## PLAN COMMISSION

September 10, 2019

**Proposal:** Plan Review – Screening Modifications for Edgewood Elementary School

**Proposal:** Plan Review – Site, Landscaping, and Screening Modifications for Meadowview Elementary School

DRAWING TITLE  
**ROOF MECHANICAL PLAN**

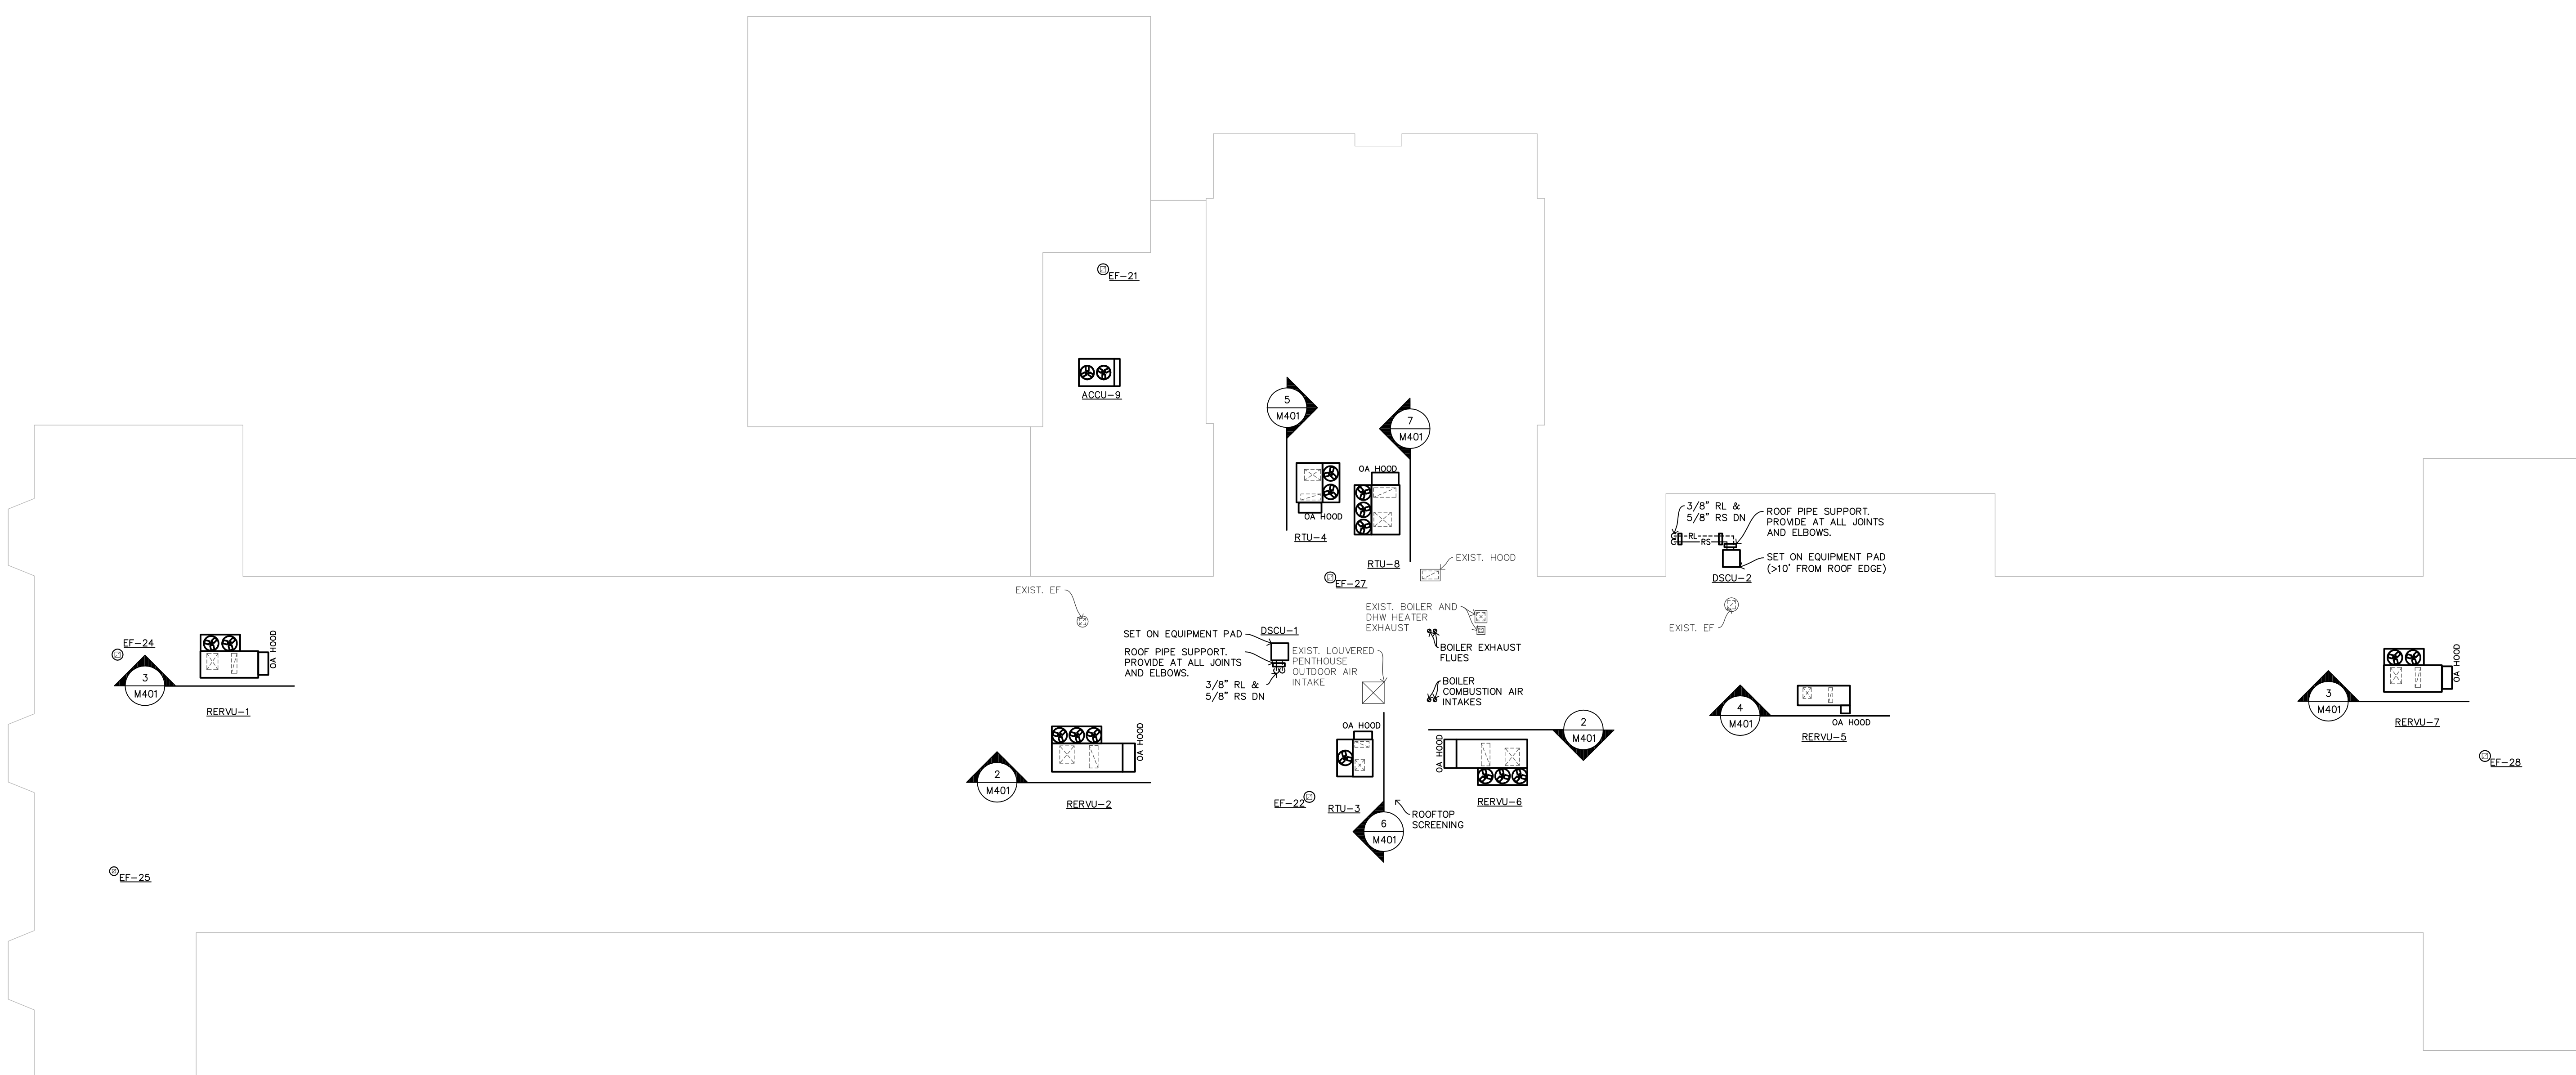
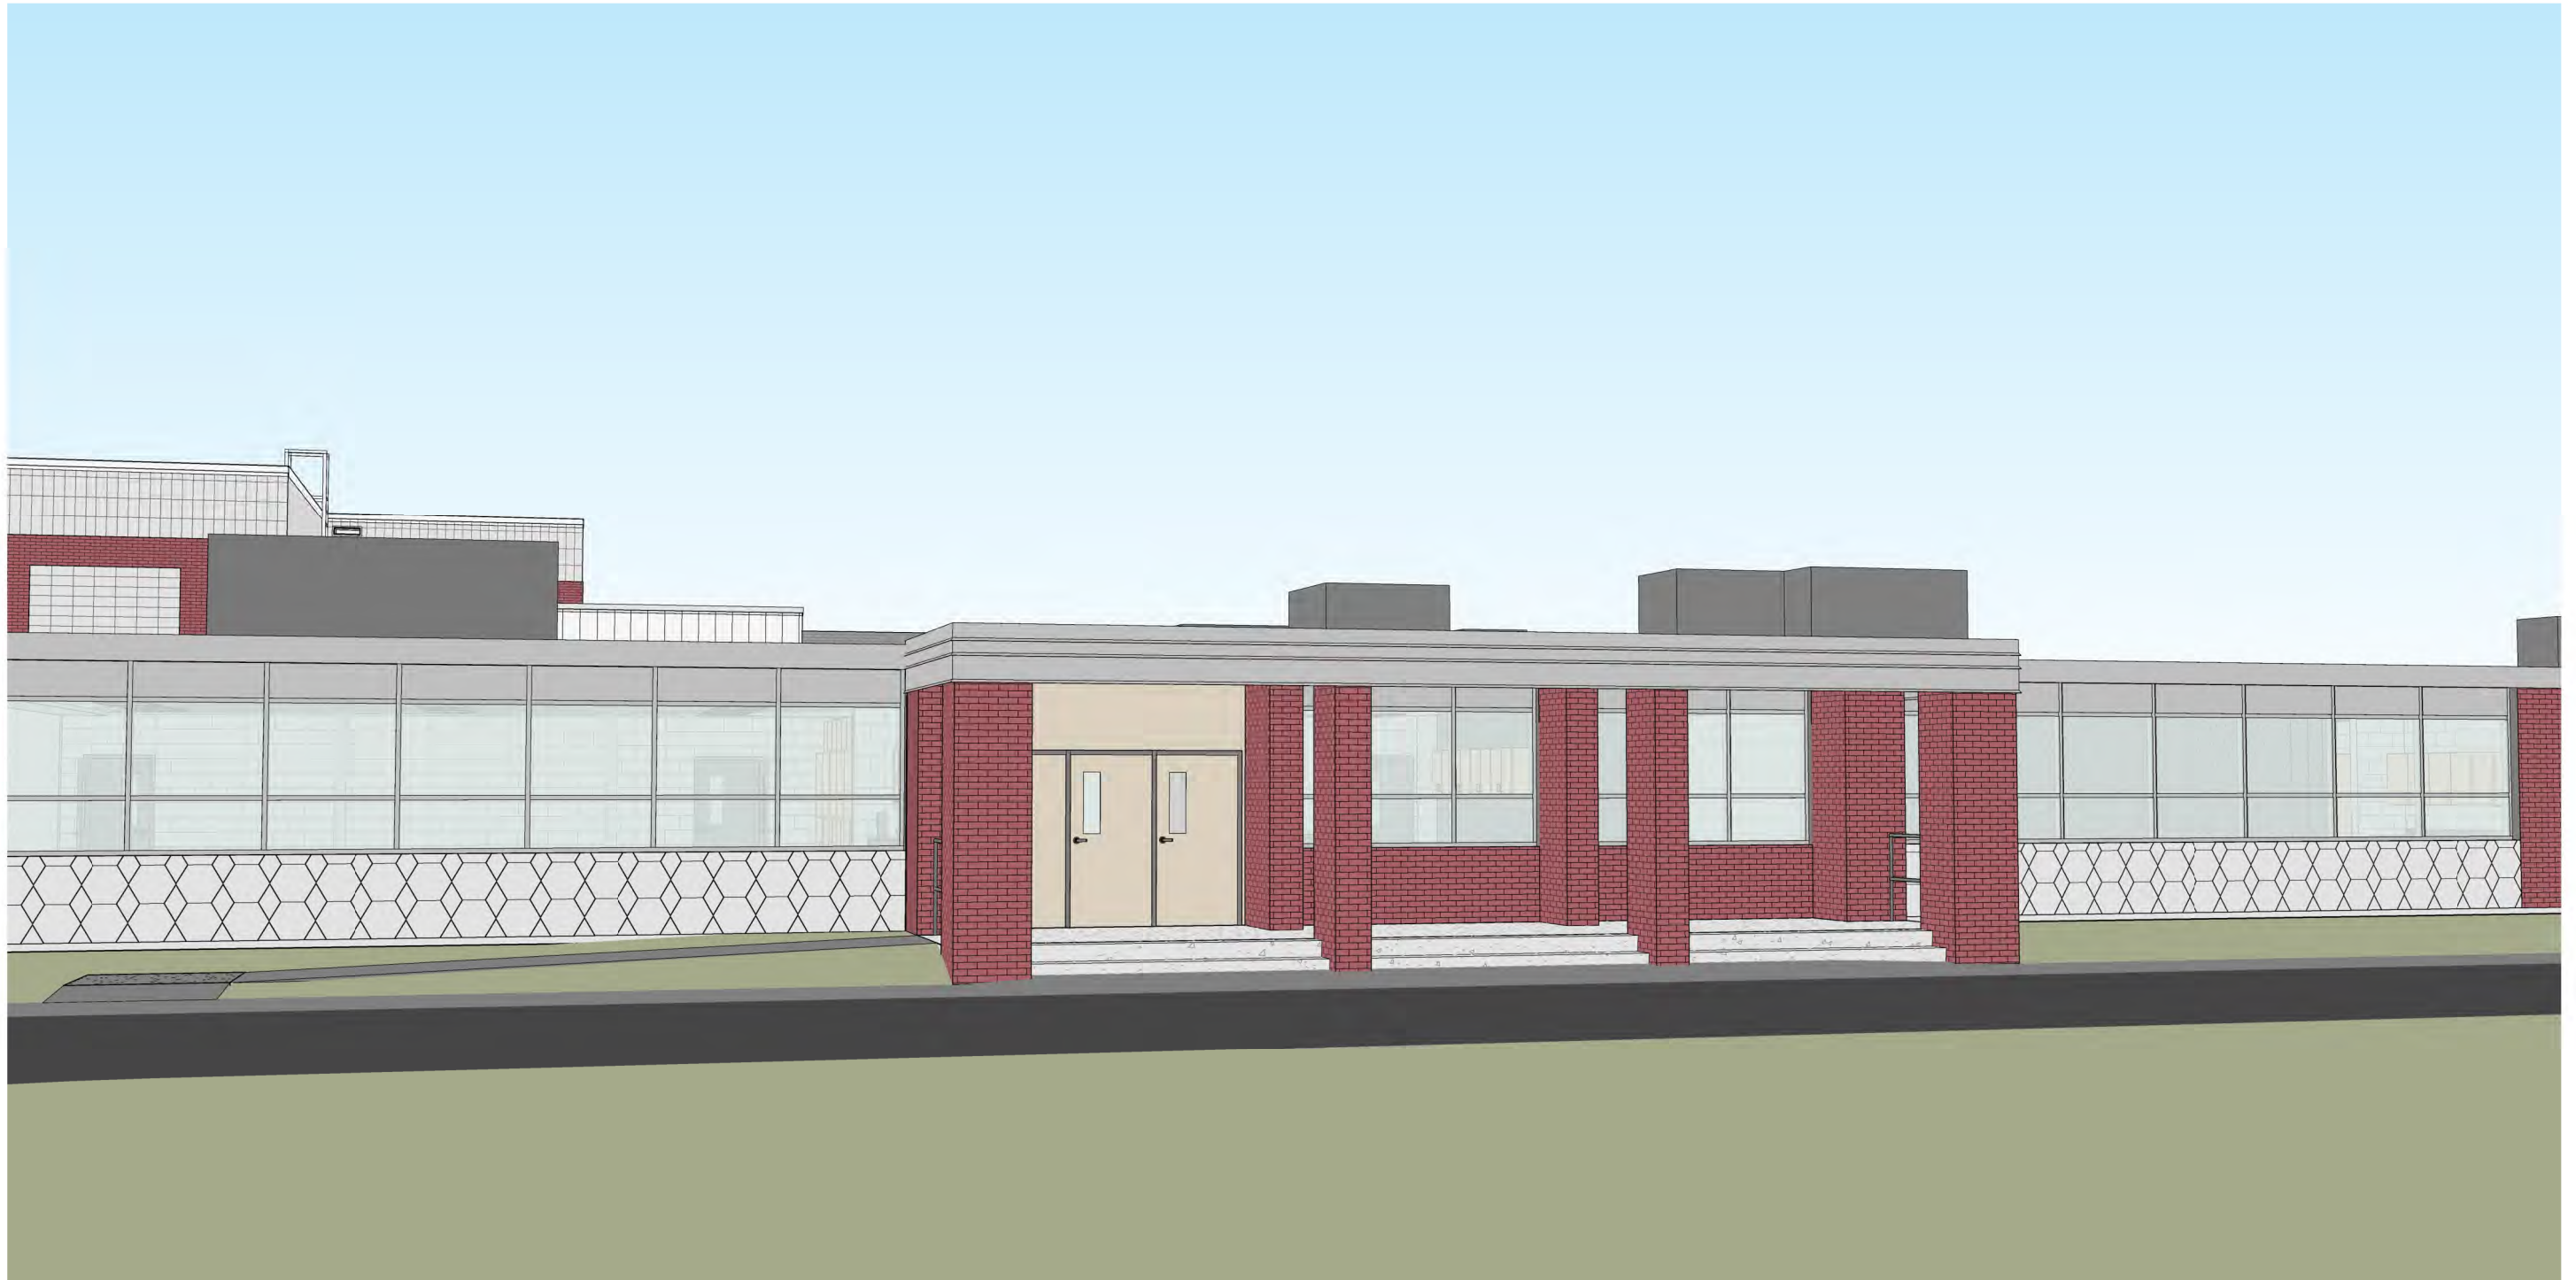
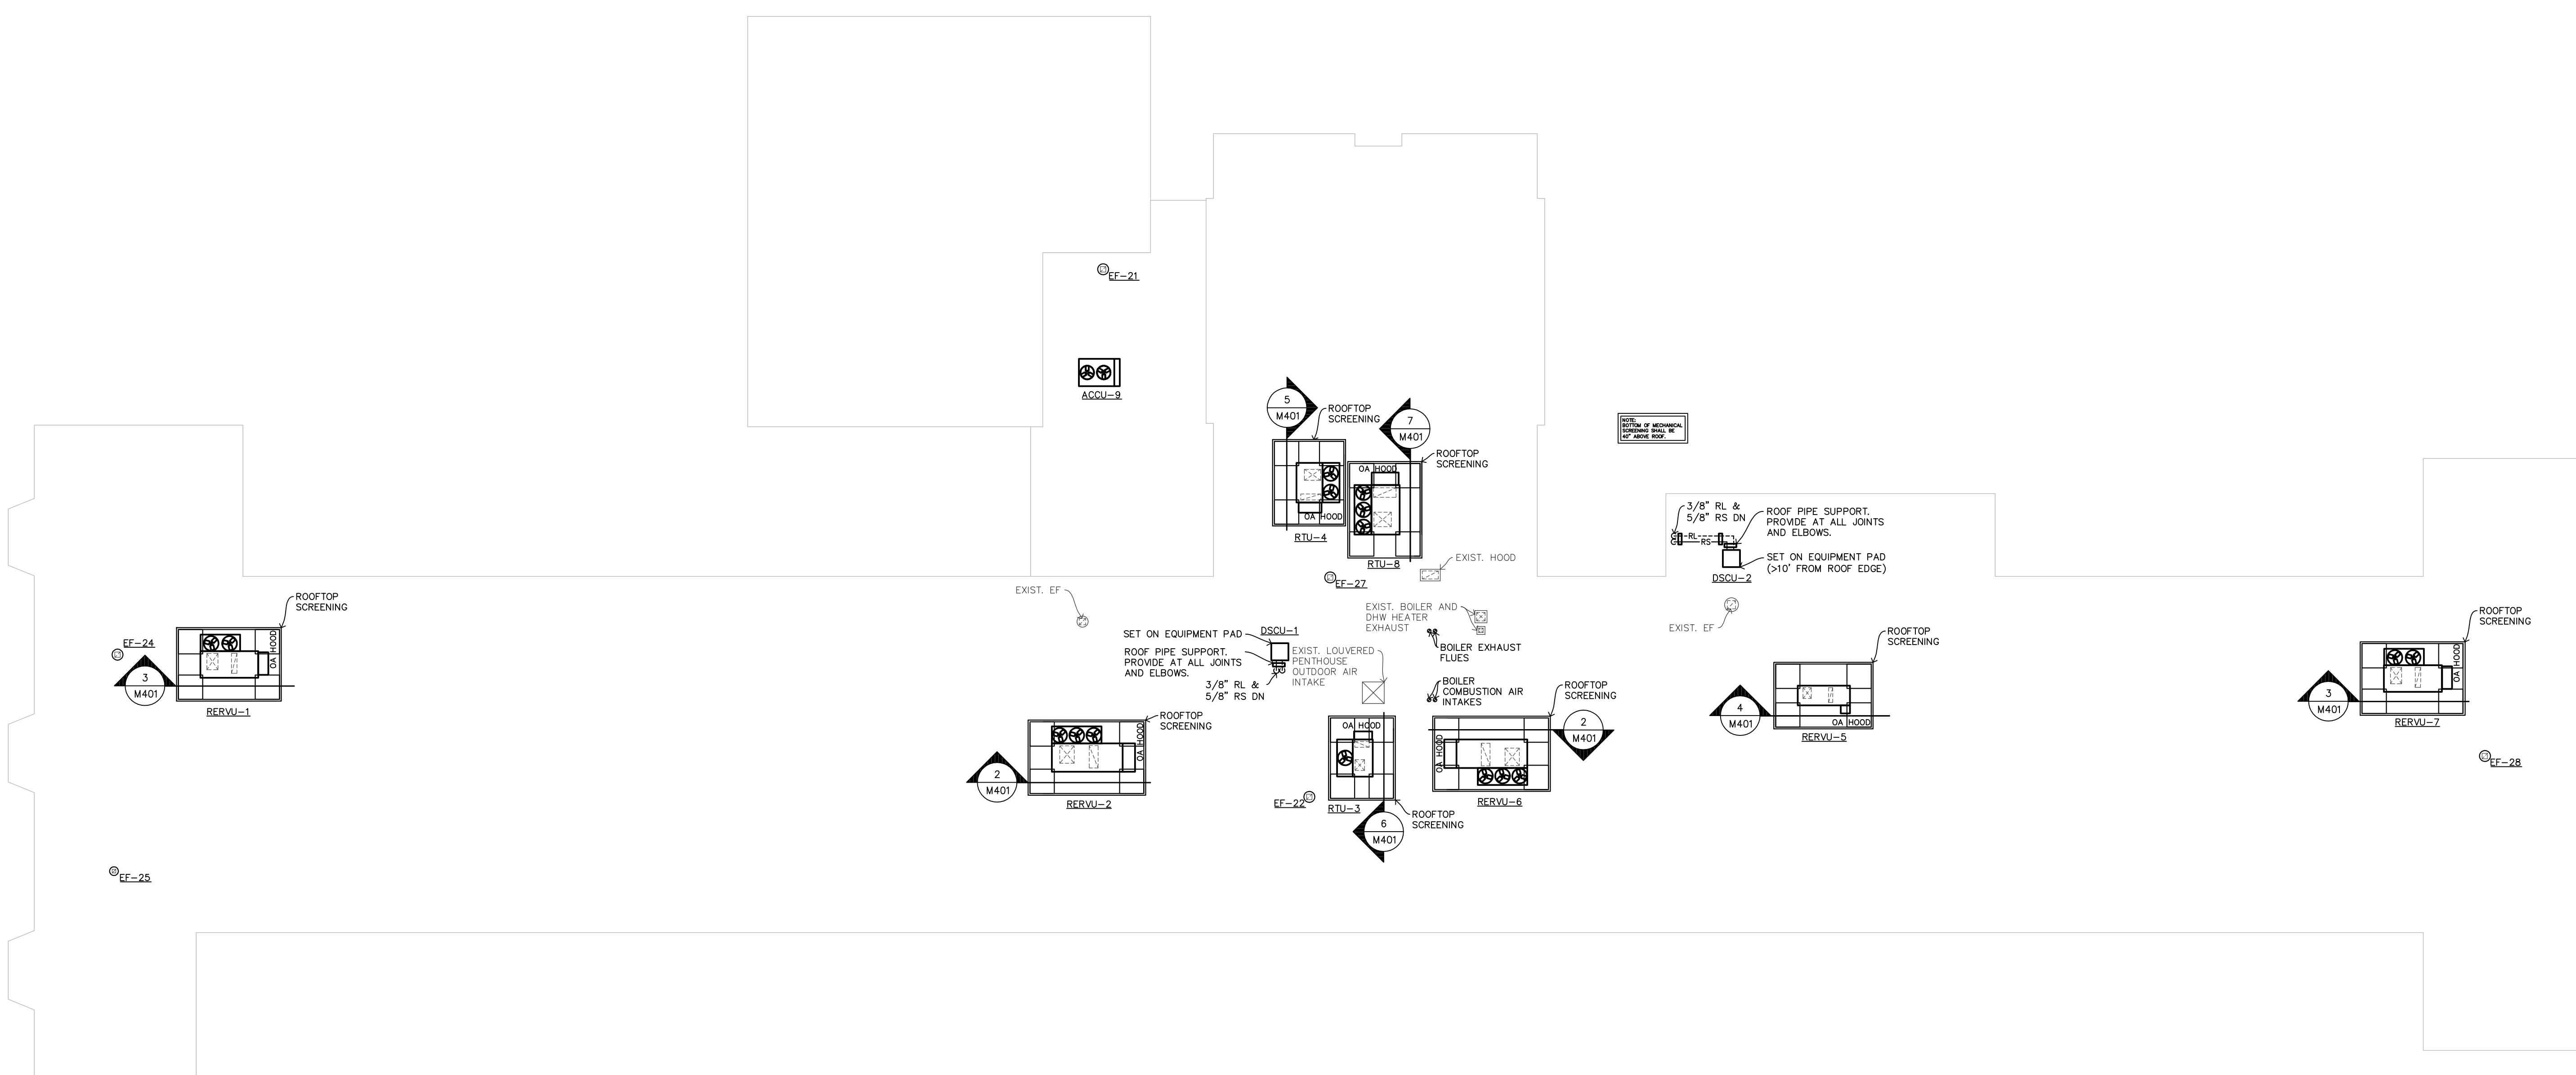
At the March 12, 2019 meeting, the Plan Commission approved site plans for modifications to the existing parking areas and internal drives, new parking areas, and an addition for a new gymnasium for Edgewood Elementary School at 8545 S. Shepard Ave. Plan Commissioners may recall that existing rooftop mechanical units (RTUs), which are not currently screened, were to be replaced with larger RTUs. Per Section 17.1010(g) of the Municipal Code, “roof mounted mechanical equipment shall be screened from casual view.” The Applicant is requesting a modification to remove this requirement from the plans.

While staff can appreciate that the existing RTUs have not historically been screened, any change to the existing conditions requires conformance with Code. This is true for any site or building modification within the City. Staff disagrees with the assessment in the submitted narrative that screening will make the RTUs more visible from the road, and that screening will be less aesthetically pleasing than exposed RTUs. Rather, screening as included in the submitted examples and throughout the City generally have the effect of blending with the architecture of the building. Those structures that do not incorporate RTU screening are more visible from the road, and are the examples of why the Code requires screening. Staff have consistently included in Conditions of Approval for Plan Commission consideration that all mechanical equipment, transformers, and utility boxes (ground, building, and rooftop) are screened from view per Code requirements, including in this case.

- Existing RTU being replaced was: 58" w x 88" l x 50" h on top of ~12" curb.
- New RERVU is: 95" w x 128" l x 50" h on top of 14" curb. The unit is longer due to energy recovery and wider due to DX cooling module.
- With the RERVU having a housing dimension of 58" w x 128" l x 50" h (not including DX module and outdoor hood), adding screening results in: 154" w x 224" l x 50" h. Therefore the screening will add 59" of obstructed view at this unit.
- Other locations we're combining existing RTU to single RERVU or moving existing roof edge located RTU away from edge
- Adding screening to RTU's on this building will add a total of 8' of obstructed view to the roof of the building.

1. That all relevant Code requirements remain in effect.
2. That all conditions of approval from March 12, 2019 remain in effect except as specifically amended herein.
3. That the proposed rooftop mechanical units are not required to be screened at this time; however, any changes to the rooftop mechanical units will require screening at the time of installation.
4. That all detailed, revised plans are submitted in digital format to the Department of Community Development prior to submission of permit applications.
